BEFORE THE	Hurunui District Council (Planning Authority)
IN THE MATTER OF	Resource Consent RC210098 – Hanmer Springs Flyride
APPLICANT	Hanmer Springs Thermal Pool and Spa
SITE	Conical Hill, Hanmer Springs

TRANSPORTATION EVIDENCE OF RAYMOND JOHN EDWARDS

On behalf of Friends of Conical Hill

DATE	30 September 2021
-------------	-------------------

Figure 1: General layout of the proposal with the ride itself shown in orange, and established walking tracks on Conical Hill shown in green.

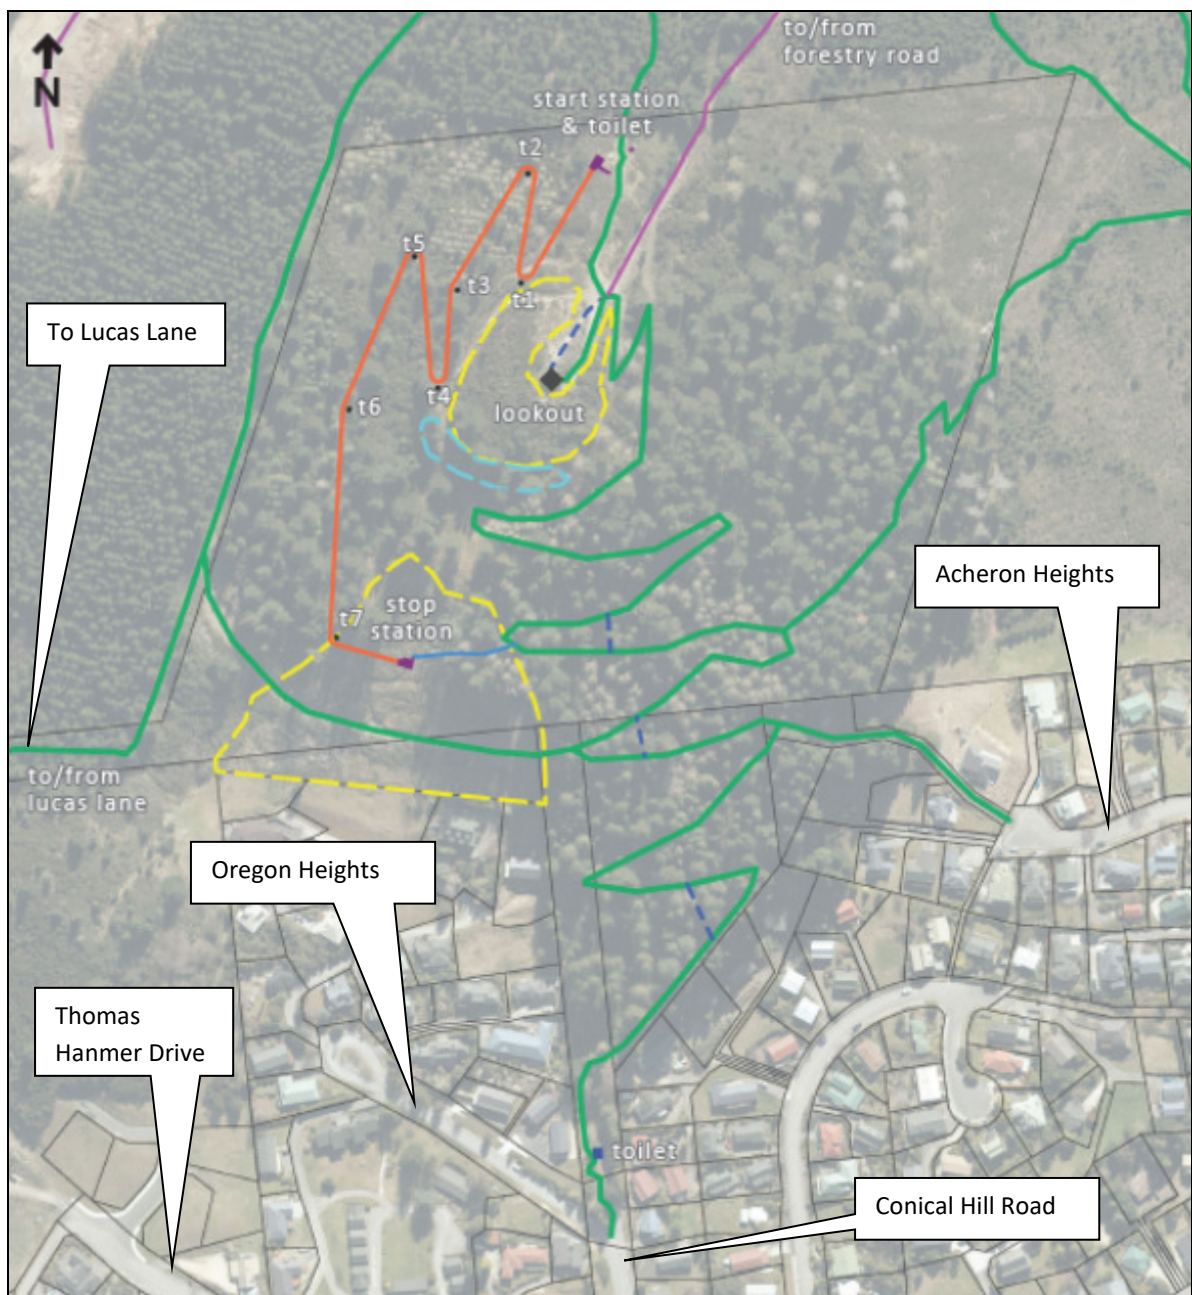
27. It is agreed that this survey cordon area is the area most likely to accommodate any on-street parking demand generated by the proposed activity. The use of the northern end of Conical Hill Road and Oregon Heights is quite obvious as it is the shortest distance from the Village centre and the walking tracks on Conical Hill. However, I note here that, contrary to the claims of Mr de Verteuil, there is potential for Acheron Heights to be used as well is the closest point to the end station for people exiting the ride as shown on Figure 1 earlier.

39. A key issue with Mr de Verteuil's analysis is that he has looked at parking available in his entire survey cordon area, and then assumed that his estimated parking demand will be spread over that entire area. He has ignored the fact that the most likely pedestrian access to the Flyride activity itself is the walking track up Conical Hill that is accessed at the northern end of Conical Hill Road. Human nature will be to park as close as possible to this location, and therefore Conical Hill Road and Oregon Heights are the most viable parking resources to cater for expected activity generated parking demand (although Acheron heights is also a convenient parking source). Mr Smith's Figure 2 is, in my opinion, a far more reliable indication of where Flyride generated parking will occur.

40. Returning to the dataset in Table 2 earlier, and survey sites 1, 2, 3, 6 and 7, the available on-street parking capacity in this location is 33 spaces. Even ignoring potential ambient parking demand generated by residential activity in these locations, Mr de Verteuil's 75% modal split parking demand scenario (34 space demand) would fully occupy all of this parking as demonstrated by Mr Smith. Even if the ambient parking demand surveyed by Mr de Verteuil was accepted as a realistic ambient parking demand level, and this is strongly questioned given that it has not been indexed to annual trading levels, then Mr de Verteuil's surveyed demand of 12 spaces plus his 50% modal split parking demand scenario (23 space demand) would also fully occupy all of this parking. It follows that this proposal has the potential to fully 'park out' Oregon Heights and the northern end of Conical Hill Road.
